Docket Number:	21-BSTD-01
Project Title:	2022 Energy Code Update Rulemaking
TN #:	238332
Document Title:	Daikin US Corporation Comments - on 45-Day Language of Proposed Draft 2022 California Energy Code
Description:	N/A
Filer:	System
Organization:	Daikin U.S. Corporation
Submitter Role:	Public
Submission Date:	6/21/2021 1:04:03 PM
Docketed Date:	6/21/2021

**Daikin Comments on 45-Day Language of Proposed Draft 2022
California Energy Code**

Figure 1. Ducted and Ductless VRF Indoor Units

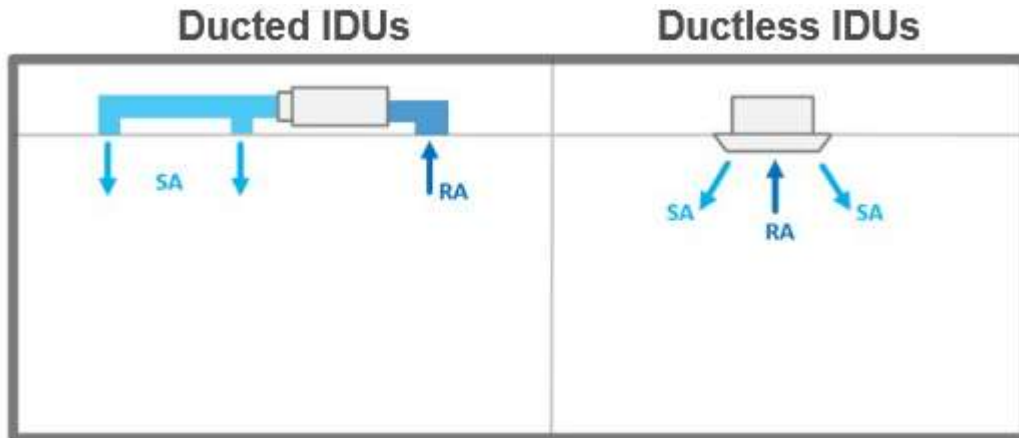
Imposing an economizer requirement for VRF indoor units raises significant and severe installation barriers. Typically, VRF indoor units are categorized as either: (1) ducted indoor units; or (2) non-ducted (i.e. ductless) indoor units. Definitions for these categories can be found in AHRI Standard 1230². For ducted indoor units, the ductwork is often limited with little-to-no ducting for return or supply air within a single zone. For ductless indoor units, return air and supply air are passed through the indoor units without any ductwork. Figure 1 provides with a visual representation of the two indoor unit categories. VRF ductless indoor units are physically unable to incorporate the use of economizers.

Therefore, we request the CEC consider modifying Exception 6 to 140.4(e)1 to include all VRF indoor units, including units with cooling capacity > 54,000 Btu/h. Alternatively, we support the proposed approach outlined in the AHRI comments on 2022 Title 24 45-day language to limit economizer requirements to only outdoor systems (i.e. indoor units inside building spaces should be exempt from using economizers).

Figure 2. Sample VRF Ducted Indoor Units Layout with OA and Economizer

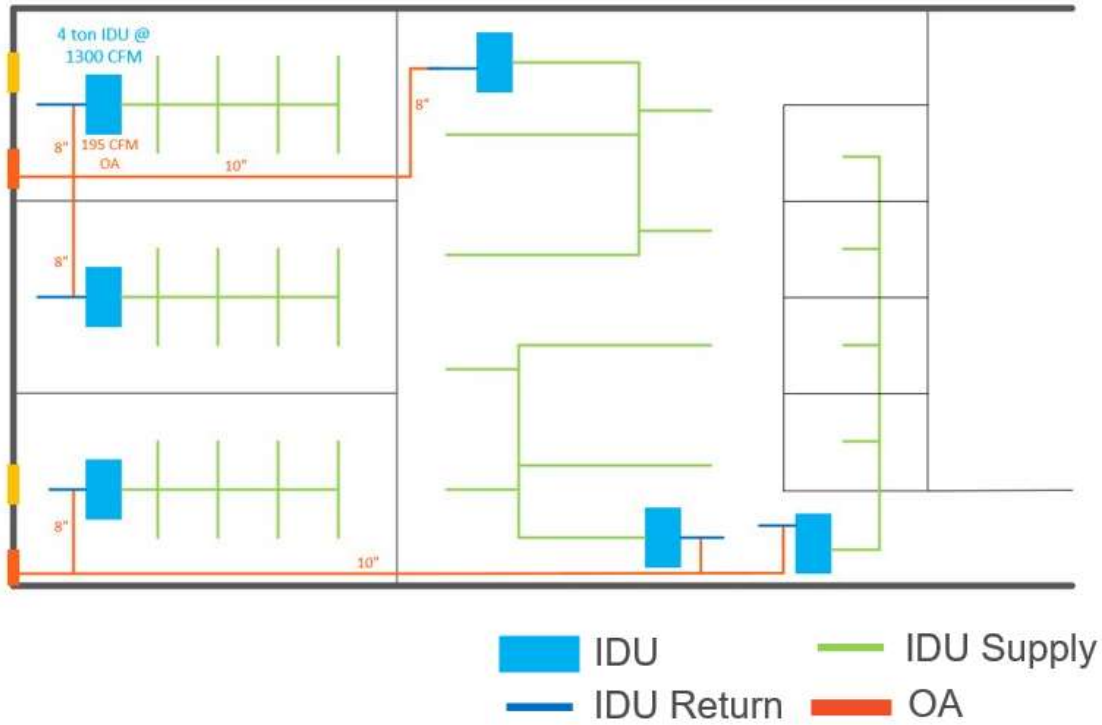
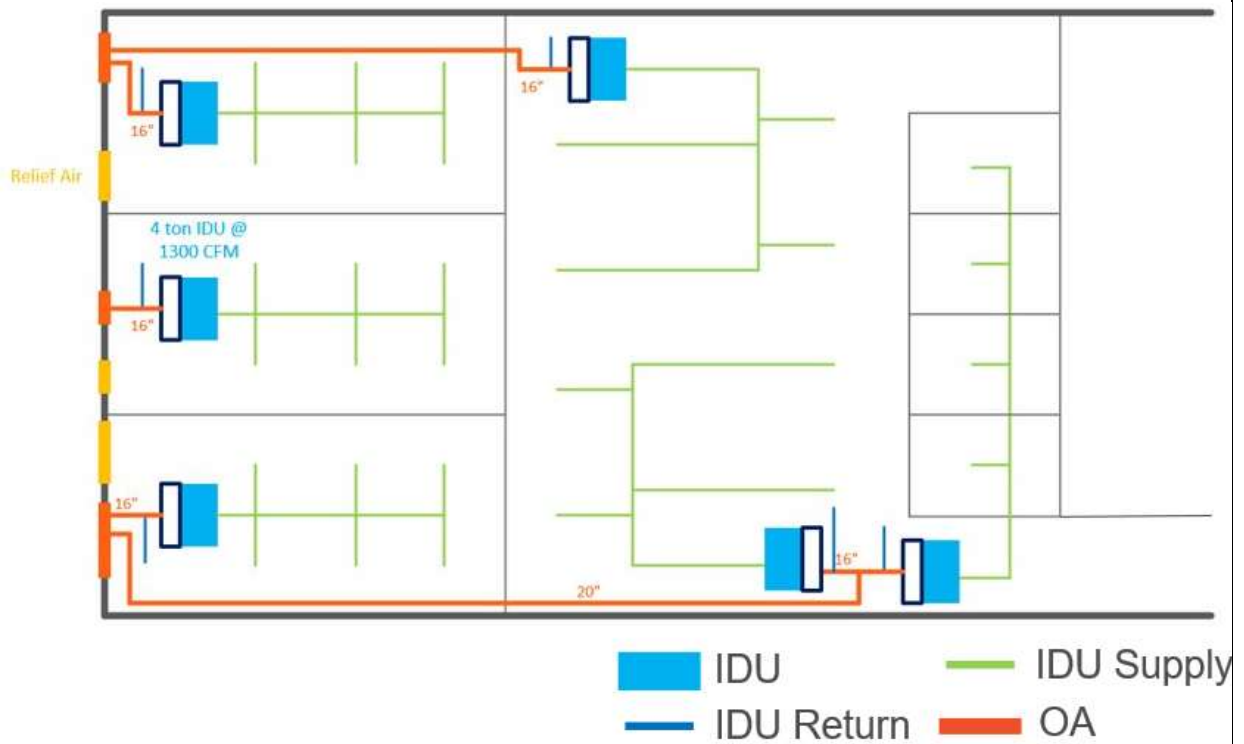
Furthermore, economizer installations with VRF ducted indoor units would lead to an increase in: (1) penetrations in the building roof and/or walls; (2) ductwork; and (3) system power input. These ducted indoor units are generally installed in their intended space conditioning zone, which may not be close to the building perimeter walls. Therefore, economizer installations with ducted indoor units present considerable complexities. Conventional packaged HVAC systems do not face the same complexities as the ventilation air is directly connected to these packaged systems with minimal impact to their installation.

Figure 2 shows a side-by-side comparison using sample building layouts of: (1) VRF ducted indoor units with economizers; and (2) VRF ducted indoor units with direct method to bring in outside air. As observed from these layouts, the number of penetrations, ductwork, and the complexities increase significantly with the installation of economizers. Based on these additional ductwork, penetrations, and complexities, the estimated differential in installation cost between the two sample layouts can go up to 5X³.
